SUBJECT: **DEMONSTRATION / DELIVERY HOLD - Compliance Recall 14C10 - Supplement #1**
Certain 2014 Model Year F-150 and Flex Vehicles with Manual Passenger Seats and
Certain Vehicles Serviced with a Suspect Seat Track Assembly
Seat Frame Clearance Adjustment

REF: **DEMONSTRATION / DELIVERY HOLD - Compliance Recall 14C10**
Dated November 3, 2014

New! REASON FOR THIS SUPPLEMENT

FIGURE 1

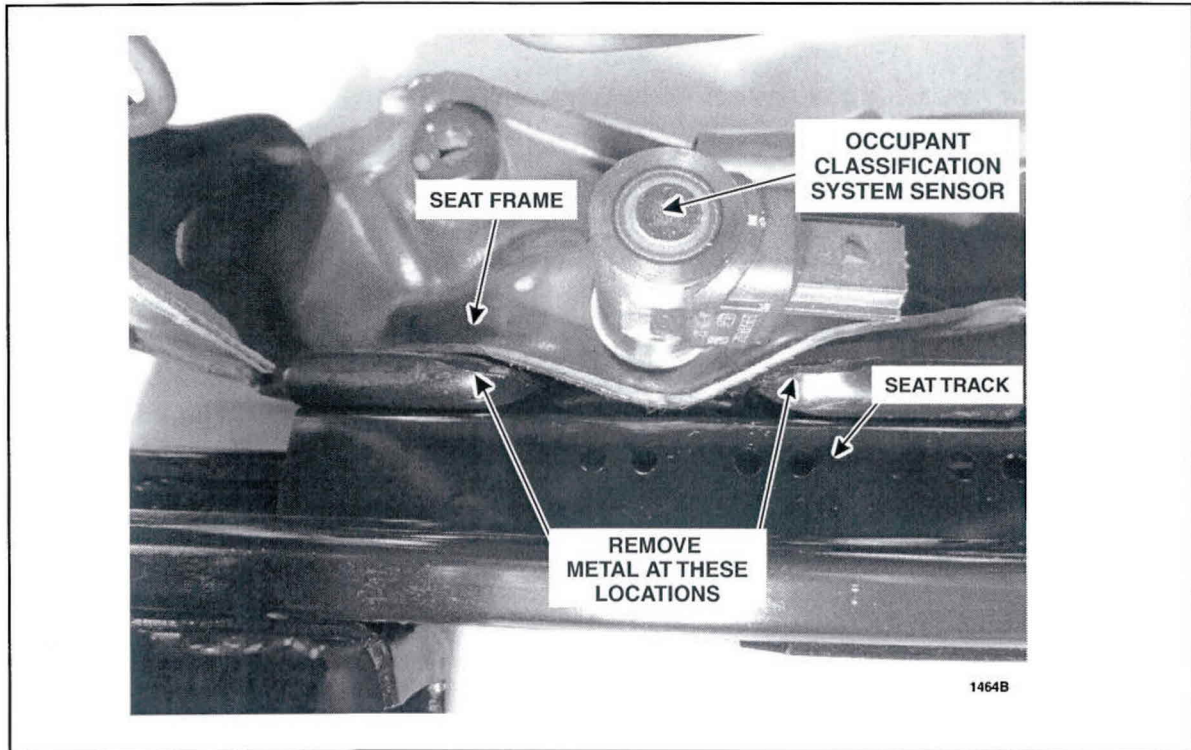
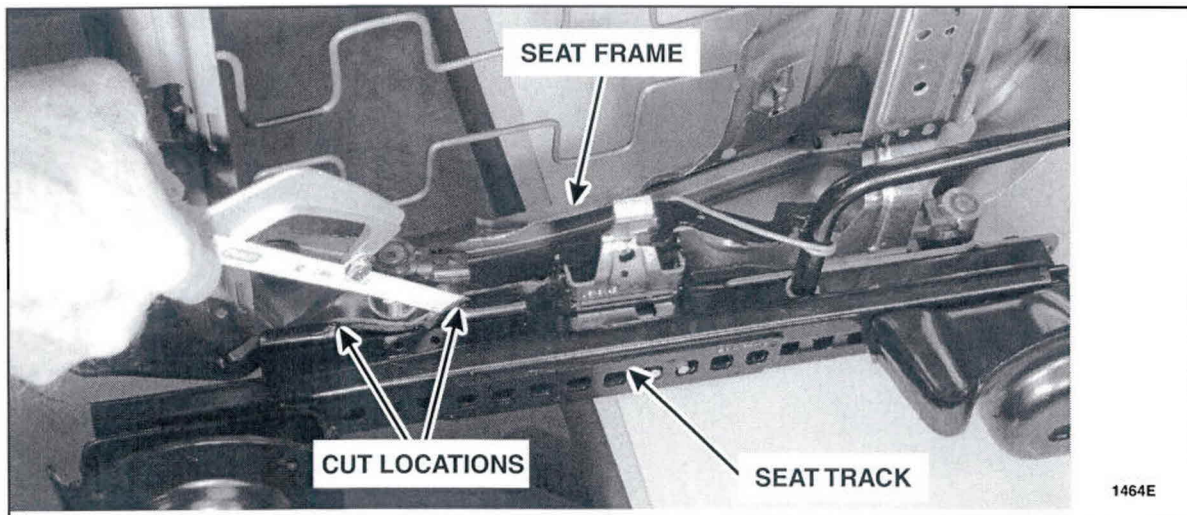
- Using a 32 teeth per inch metal hacksaw blade, insert the blade down alongside the seat frame. Using gentle force on the hacksaw blade, cut the metal as you move the blade through the contact area. Do this at both locations at each side of the sensor. See Figures 1 and 2 (Seat disassembled for clarity).

FIGURE 3

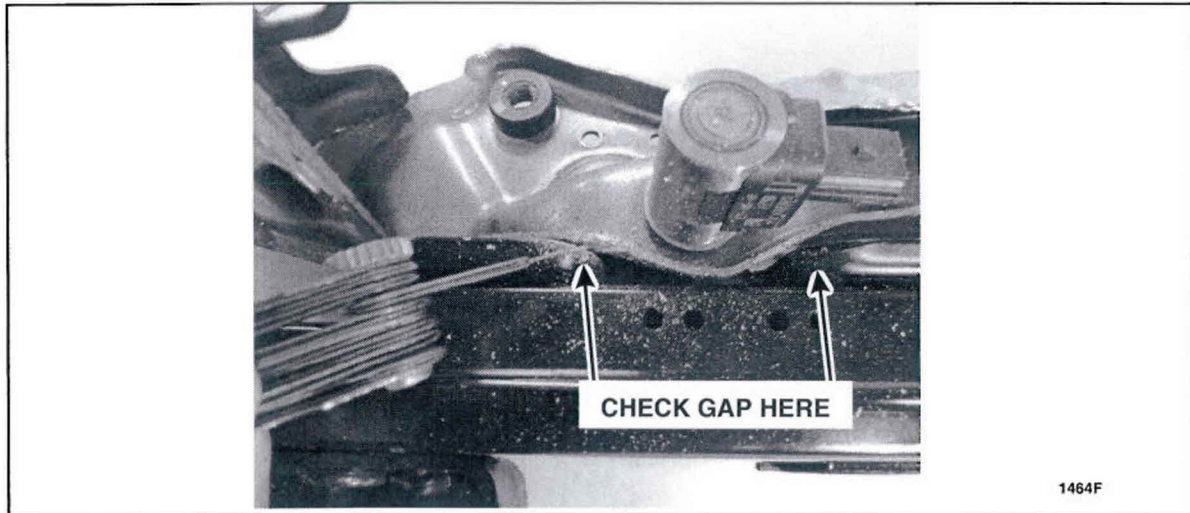
- Using a wire feeler gauge, check to make sure that there is a minimum 0.7 mm (0.028 in) clearance between the seat frame and seat track. See Figure 3.
